DATE: 07.19.2019
TO: ProTrak
FROM: Bill McDow
Transportation Planning

ECHO FARMS PARK [TRC Plan Review #5]

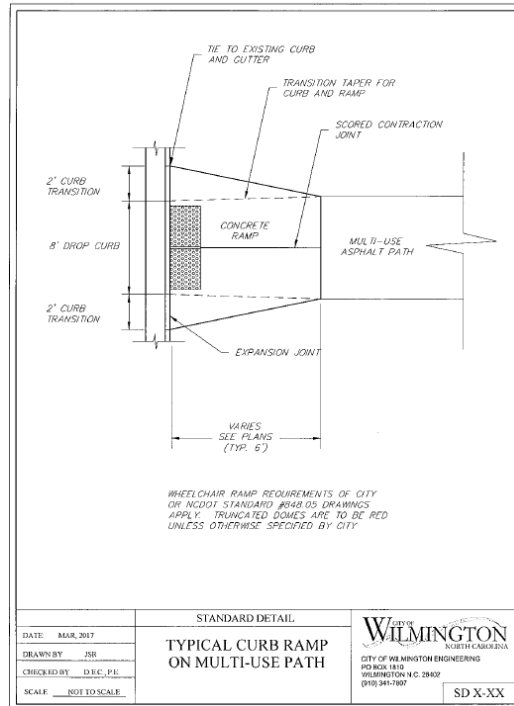
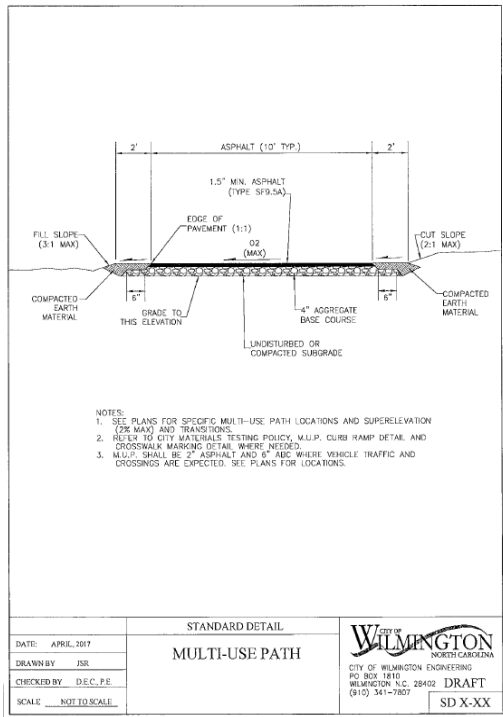
1. Please revise labels on the plan (sheet C-2.6), from “Proposed 10’ Wide Asphalt Walking Trail” to “Proposed 8’ Wide Asphalt Walking Trail”.
2. The proposed section/ site plans do not show the correct detail for the 10’ Asphalt Multi-Use Path on sheet C-3.1. The incorrect section can be removed from the plans. The path must have correct shoulder, materials and slope. An example of the City Multi-Use path is shown below.
